**From:** Amadi, Eric A - DNR  
**Sent:** Tuesday, November 23, 2021 6:25 PM  
**To:** Julie A Zimdars  
**Subject:** FW: BRRTS 02-41-553761 and 06-41-560068 Connell Wabash Site - RAOR Addendum/Pre-Design Work Plan (Rev 2)  
**Attachments:** BRRTS 0241553761 & 0641560068 Connell Wabash RAOR Addendum R2 Sep 28 2021.pdf

Hi Eric – On behalf of Connell Aluminum Properties, attached is the *Addendum (Revision 2) to the Remedial Action Options Report (RAOR) and Pre-Design Sampling Work Plan* for the Former Koppers Tar Plant and Wabash Alloys Site that incorporates WDNR comments received on July 9, 2021.

**Addendum (Revision 2) to Remedial Action Options Report (RAOR)  
and Pre-Design Sampling Work Plan - Connell Aluminum Properties, LLC  
Former Koppers Tar Plant and Wabash Alloys Site  
9100 S. 5<sup>th</sup> Avenue, Oak Creek, WI 53154  
BRRTS# 02-41-553761, FID#241379050  
Connell VPLE BRRTS #:06-41-560068**

**FIGURE 3**  
**FIGURE C41 (REV. SI REPORT)**

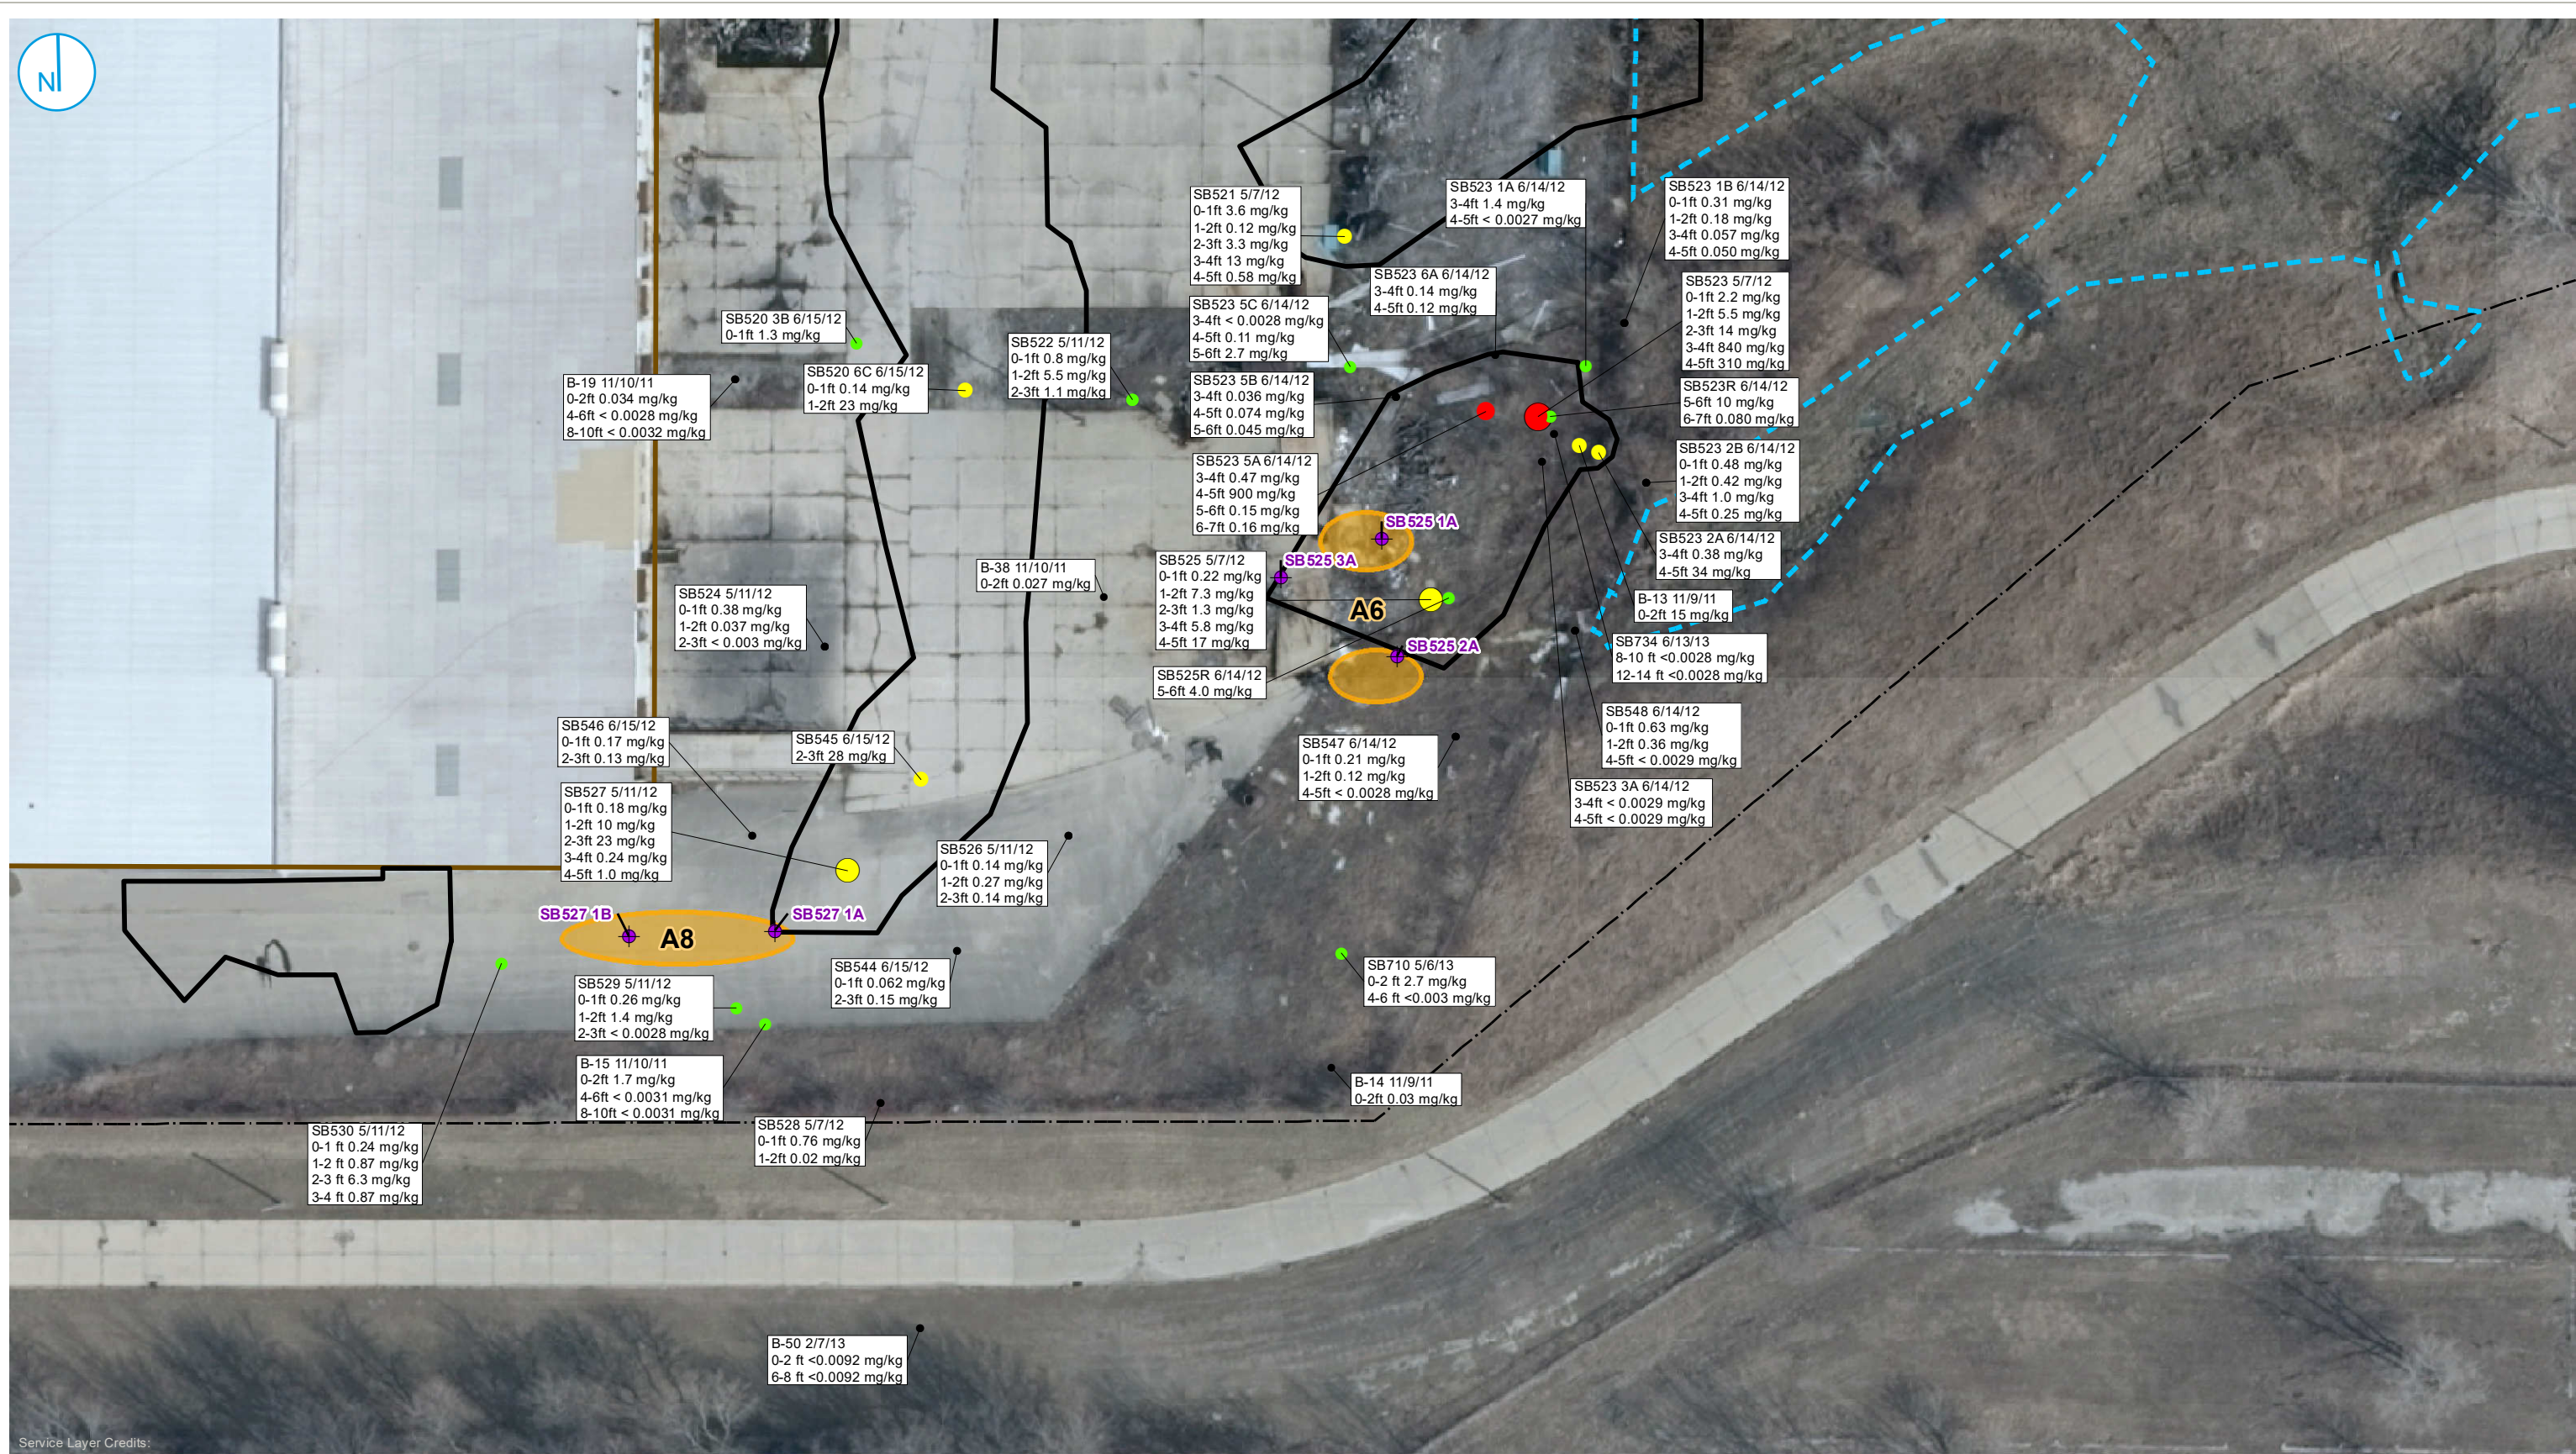
- Figure 3 – Revised Figure C41 SI Report – PCB Soil Data – South Yard TSCA Area for purposes of showing more specifically the additional PCB sampling locations related to comments A6 and A8.

**FIGURE 4  
FIGURE C42 (REV. SI REPORT)**

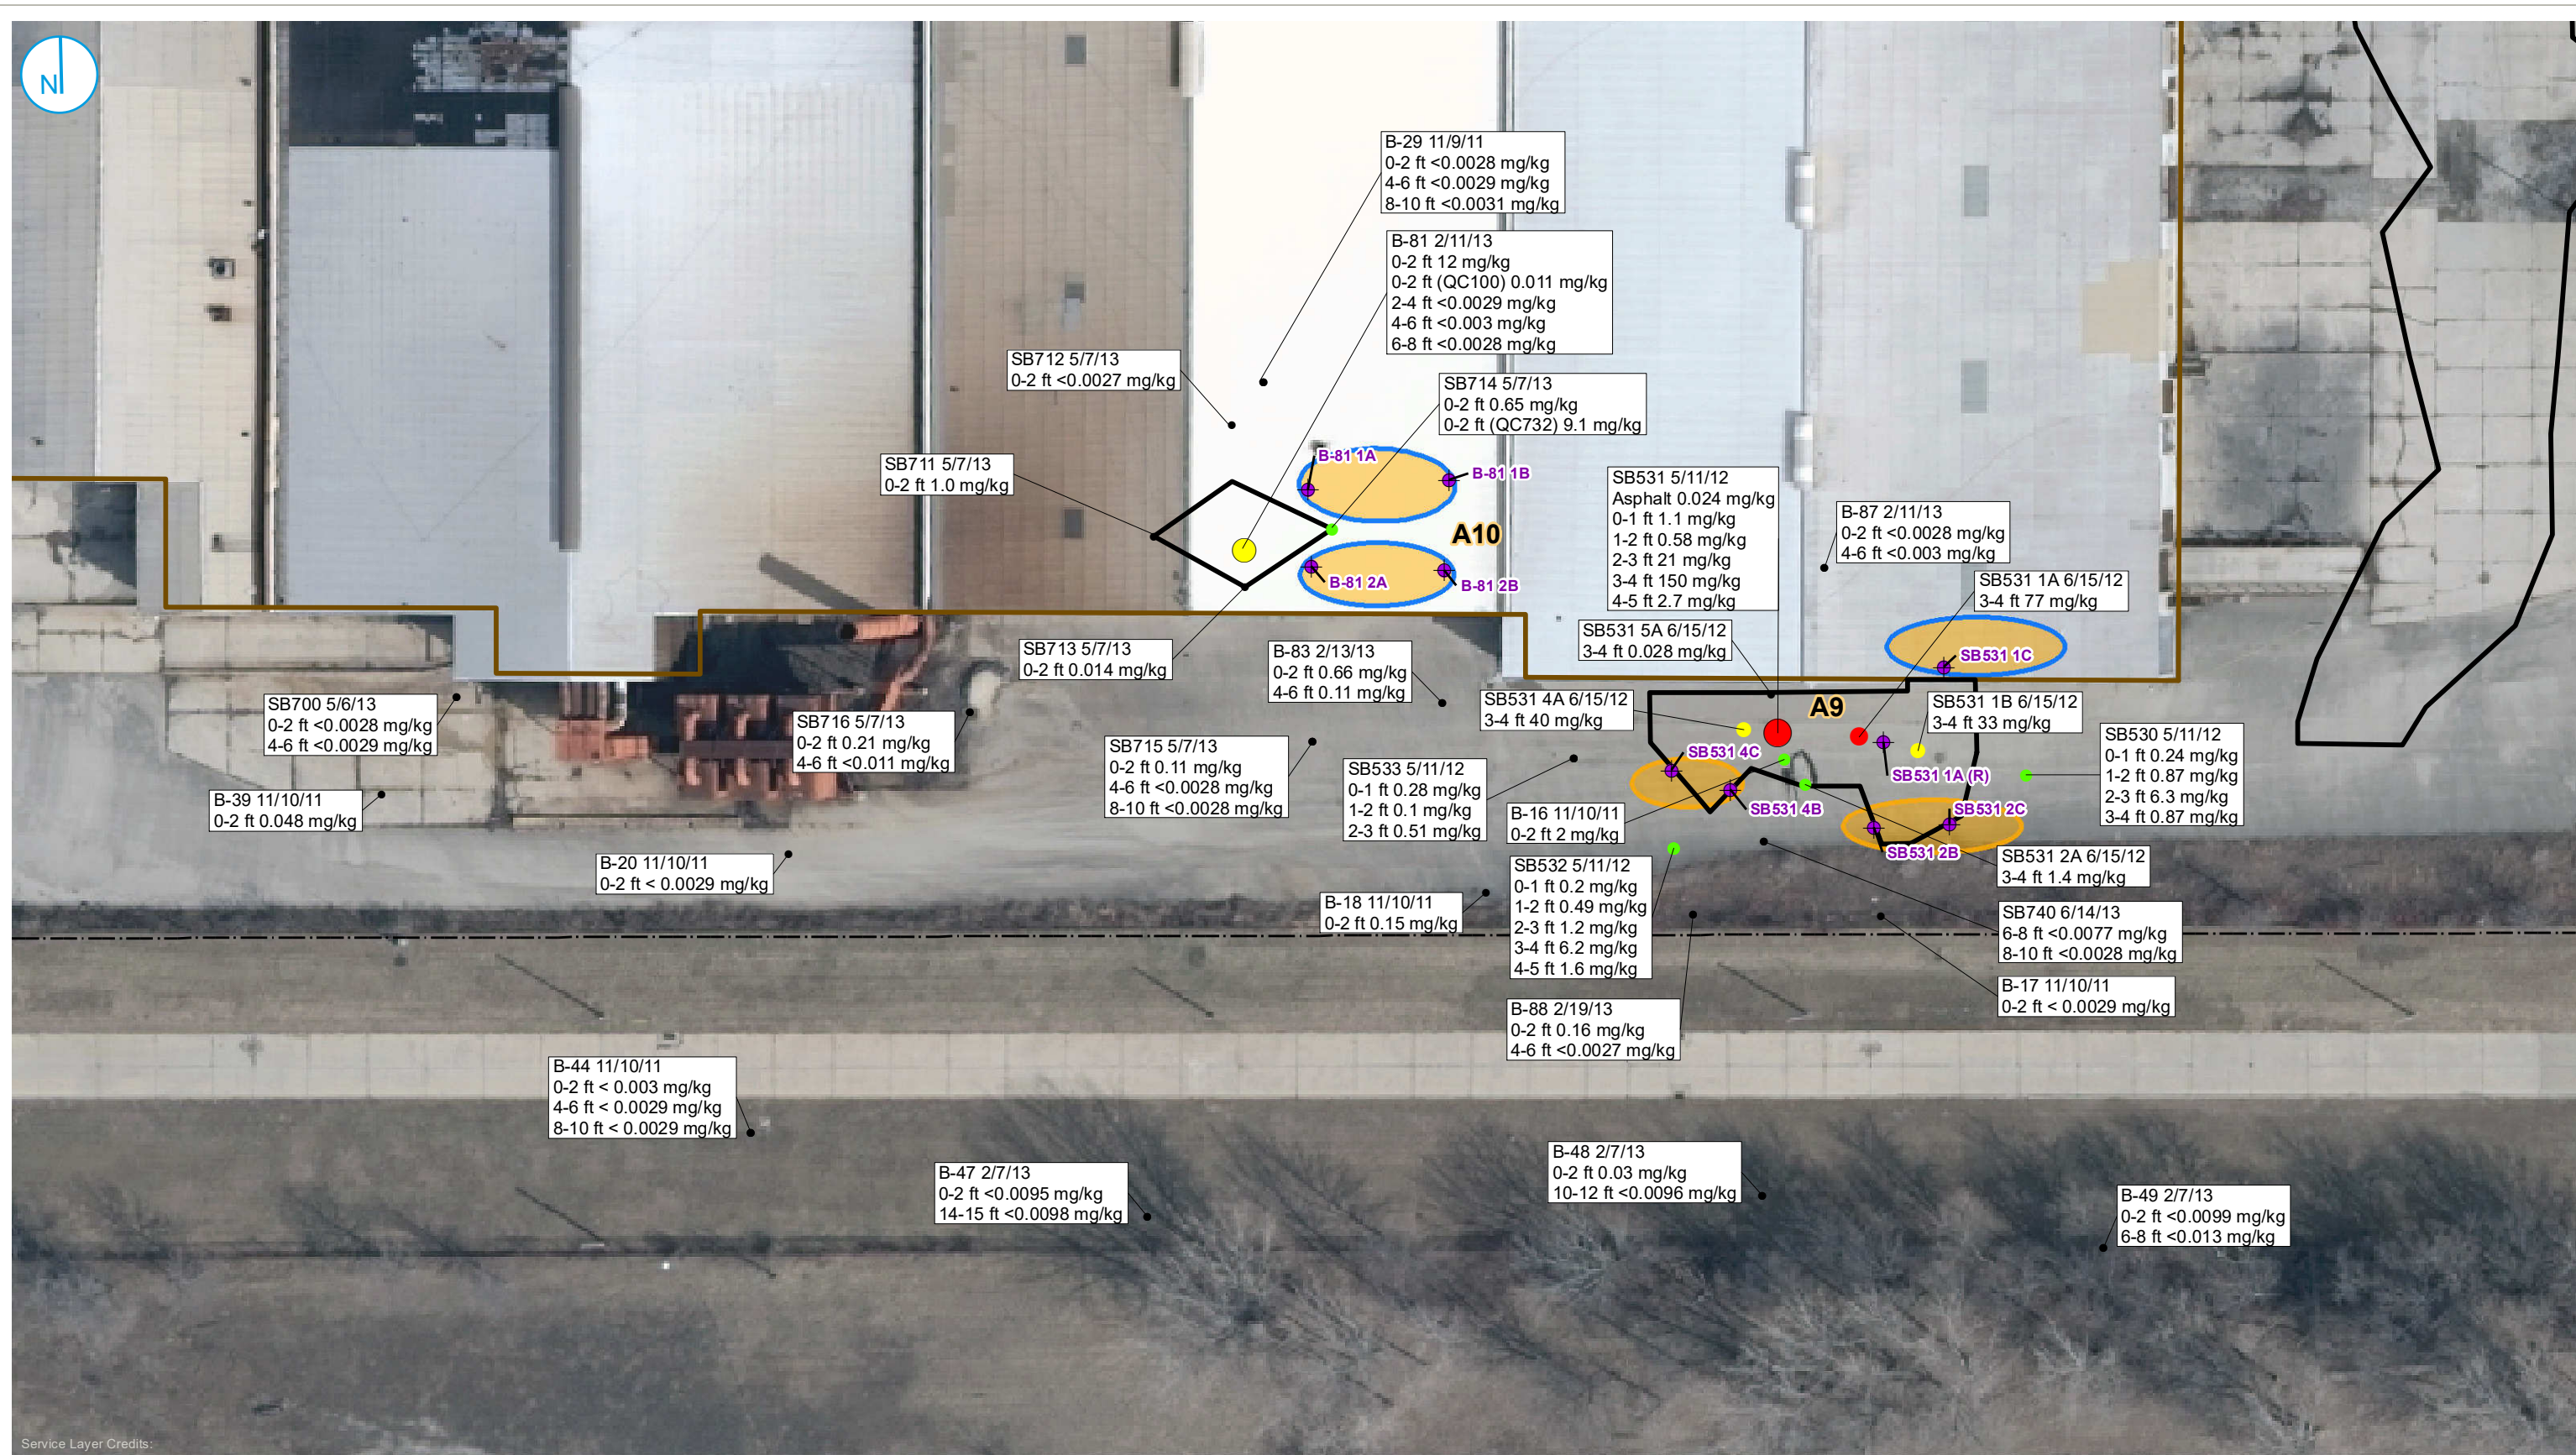
- Figure 4 – Revised Figure C42 SI Report – PCB Soil Data – South Exterior TSCA Area for purposes of showing more specifically the additional PCB sampling locations related to comments A9 and A10.

**FIGURE 5**  
FIGURE 8 (REV. RAOR REPORT)

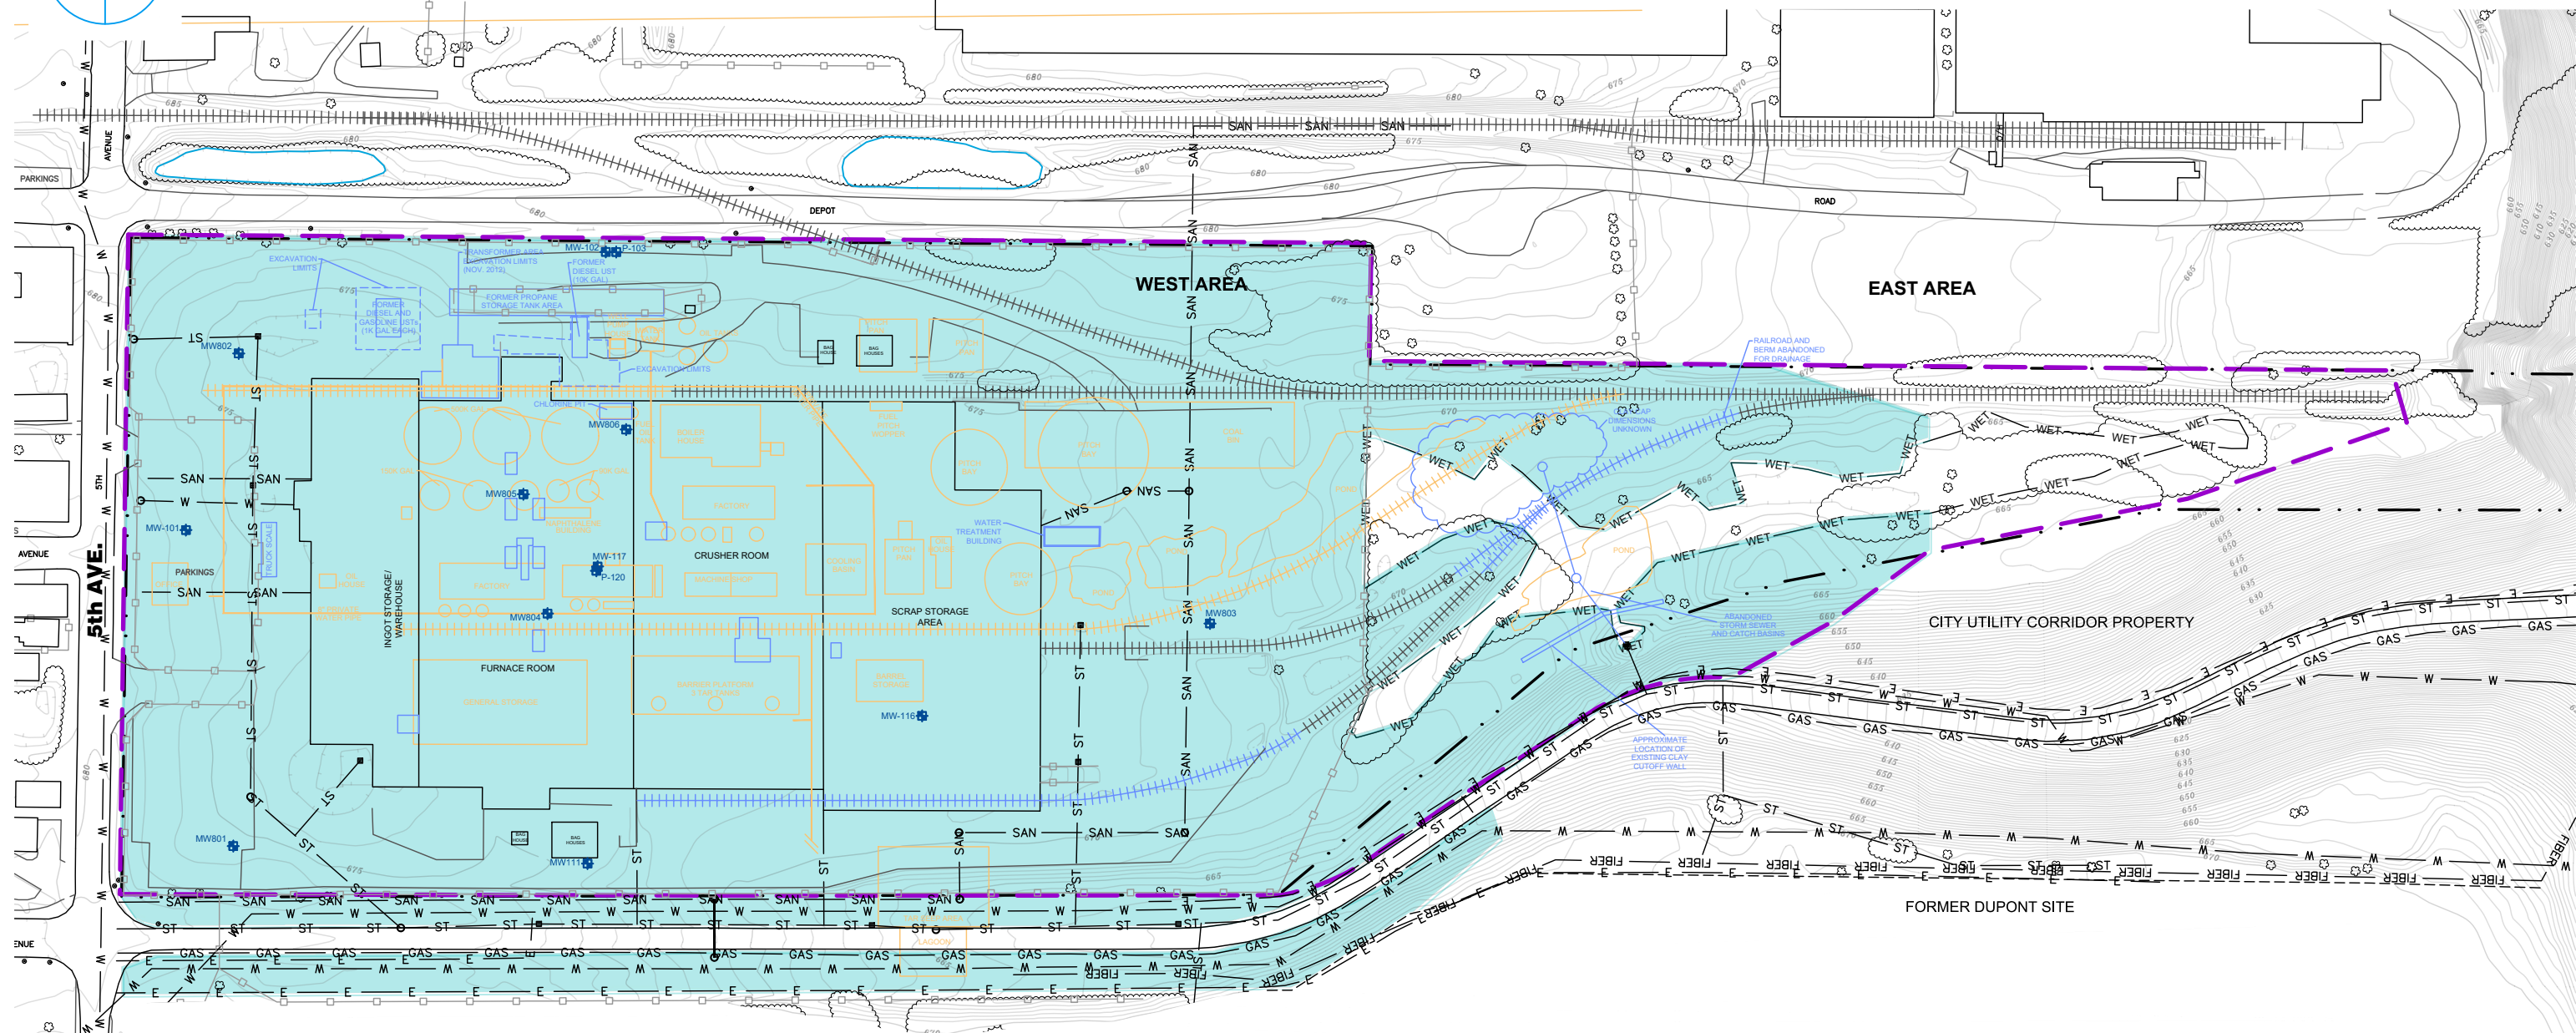
- Figure 5 – Revised RAOR Figure 8 - PCB and Arsenic Soil Barrier (Alternative S-3) for purposes of showing the revised estimated cap extent in both the western and eastern areas.
- Figure 6 – Revised Figure C35 SI Report – PCB Aroclor 1242/1248/1254/1260 Soil Concentrations (0-4 feet bgs) for purposes of showing PCB sampling results and proposed cap extents.
- Figure 7 – Revised Figure C1 SI Report – Arsenic Soil Concentrations (0-4 ft bgs) for purposes of showing arsenic sampling results and proposed cap extents.

As shown in the revised figures, the PCB and Arsenic Soil Barrier will extend to the property boundaries at the western extent due to the widespread contamination. Any future management of soils would need to follow requirements of Wisconsin Administrative Code ch. NR 718.
